Smart Motorways Programme

M4 Junctions 3 to 12 Smart Motorway

Non-Material Change

Huntercombe Spur Overbridge

Figure 2 2021 NMC Design of Huntercombe Spur overbridge

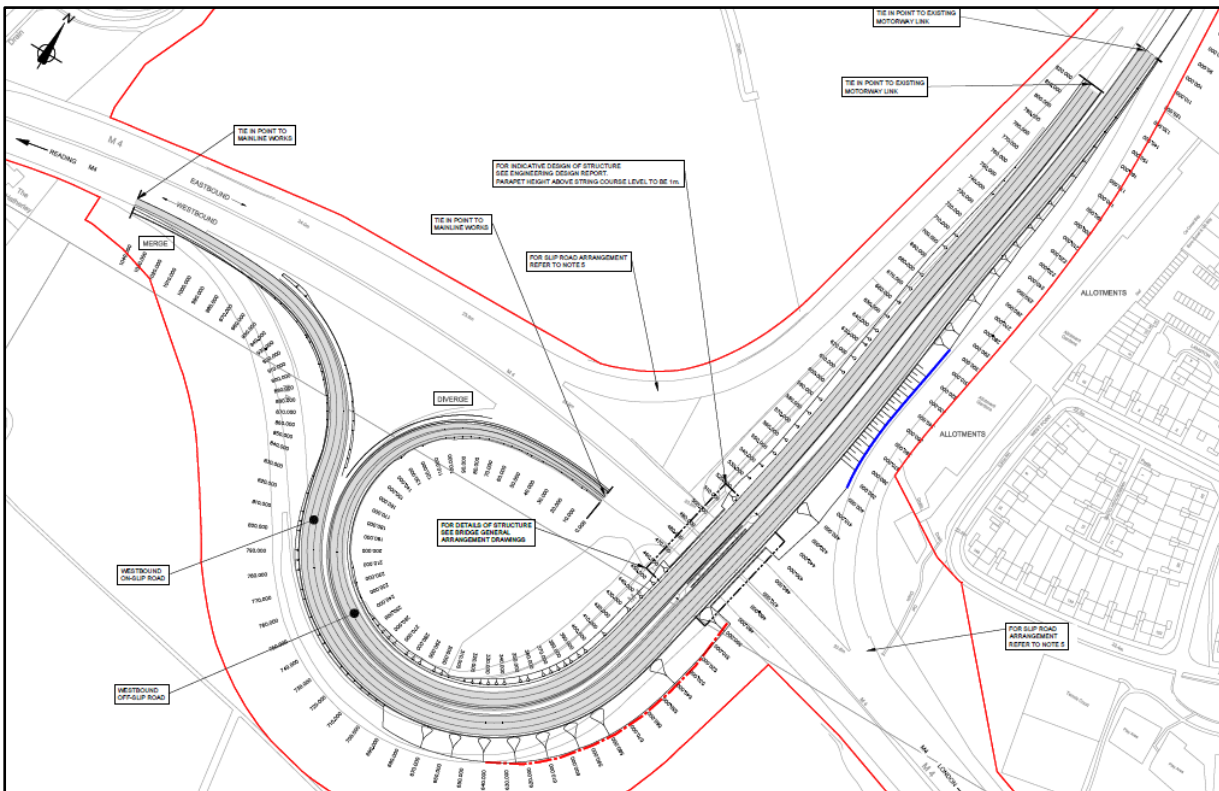
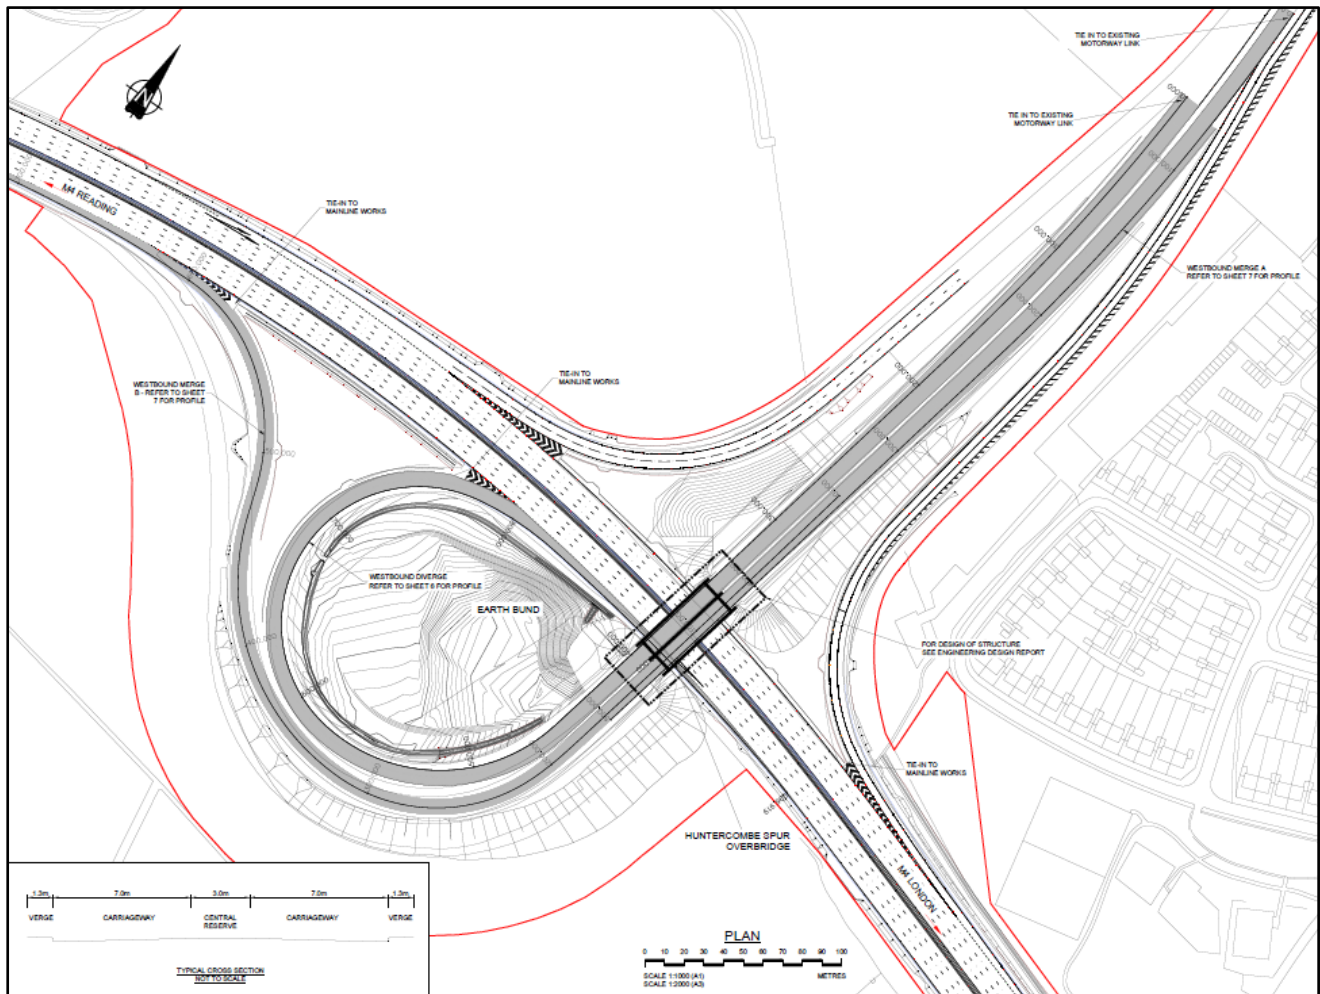
The 2021 NMC Design of Huntercombe Spur overbridge is shown in Figure 2. This replaces the previously proposed pair of offline structures with a single wide online structure. The new bridge structure will be a steel composite single span structure, with 8 steel girders instead of the original 12. To facilitate the movement of traffic during construction, a temporary offline bridge will be built to the east of the main structure.

The alignment of the proposed design has changed to tie into the existing highway sooner (approx. 70m earlier south of the structure and 130m earlier north of the structure), reducing the scope of pavement works. As a result of this, the vertical alignment of the Spur has been lowered with the need to tie-in to the existing pavement.

As a result of switching to a new bridge structure design, the alignment of Huntercombe Spur overbridge over the M4 has moved west by up to 17m. A result of this is that the Spur approaching the M4 overbridge is no longer constrained by the eastbound merge slip. Therefore, the 100m long retaining wall on the north-east corner in the previous design (shown in blue in Figure 1) has been replaced by steepened earthworks.

Figure 6 Extract of detailed landscape design shown on the ENGINEERING AND DESIGN REPORT, ENVIRONMENTAL MASTERPLAN (P01, S2, HA514451-CHHJ-ELS-SZ_ZZZZZZZ_Z-DR-LD-5200 to 5265, 18/02/22)

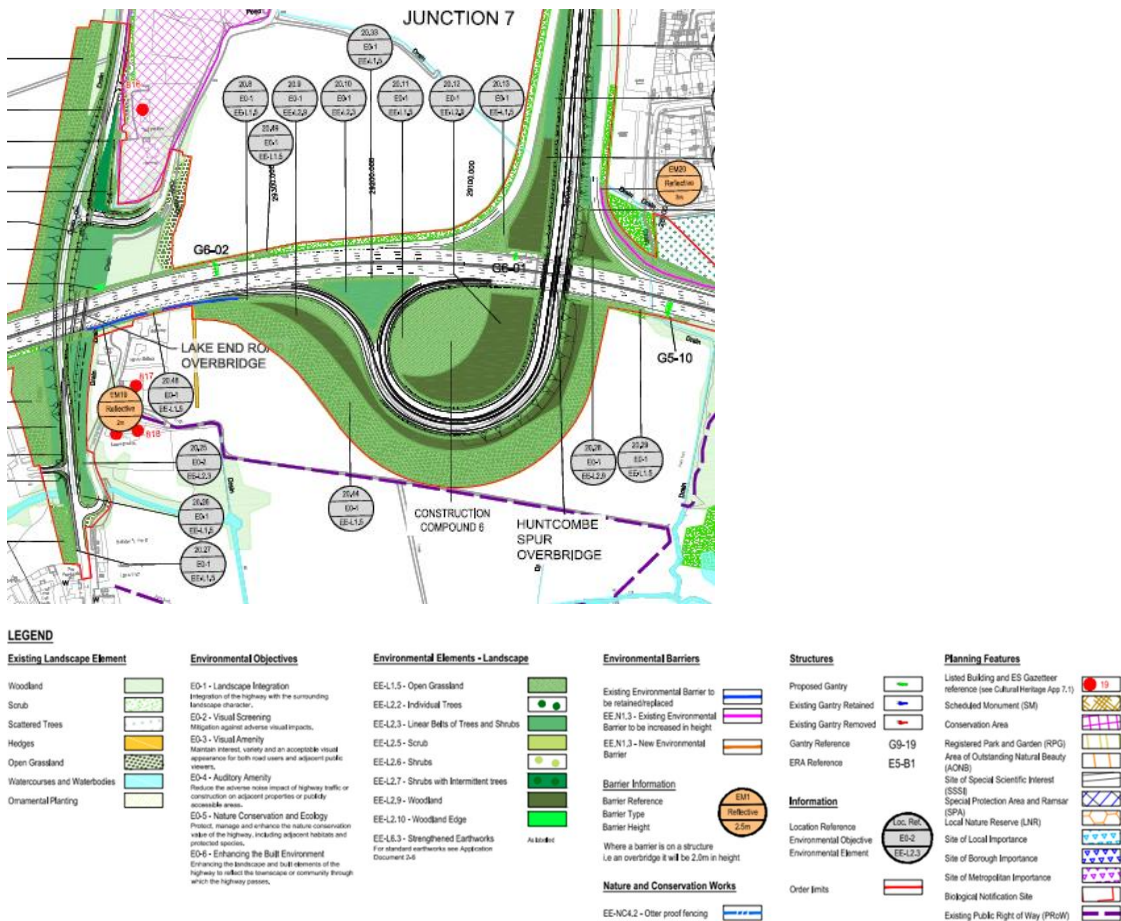
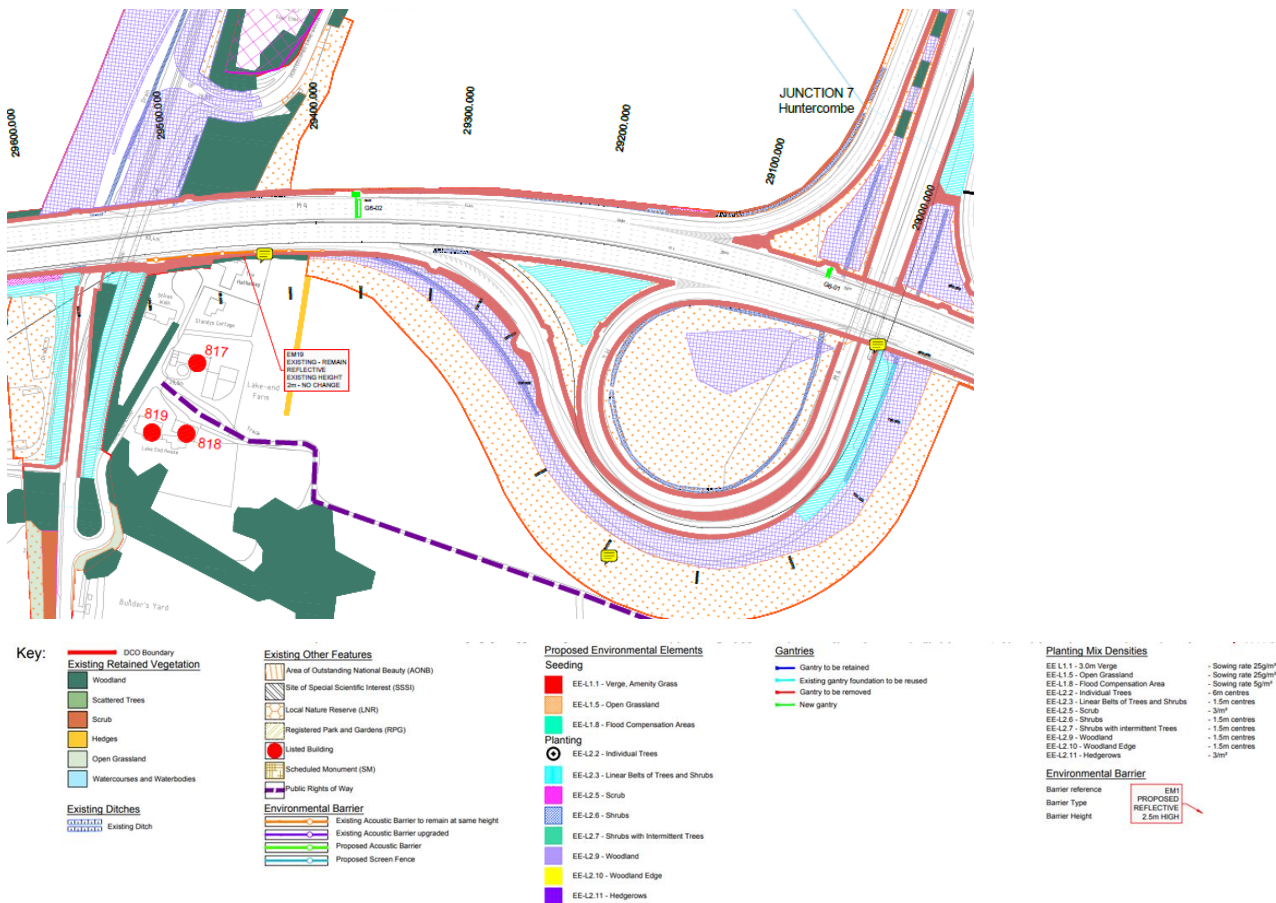
Reduced planting of woodland (EE L2.9) in the “teardrop” for screening traffic on the south western side of the bridge. Reduced planting of trees and shrubs (EE L2.3) along the slip roads along the eastbound off-slip between Lake End Bridge and junction 7 south of Huntercombe Conservation Area and listed Building 816. Mitigation planting not always possible due to re-alignment of road leaves only narrow strip of seeding.

Additional planting of trees and shrubs (EE L2.3) required in the north of the eastbound on-slip in the North West Quadrant of junction 7, adjacent to residential properties and allotments in the south west of Cippenham.
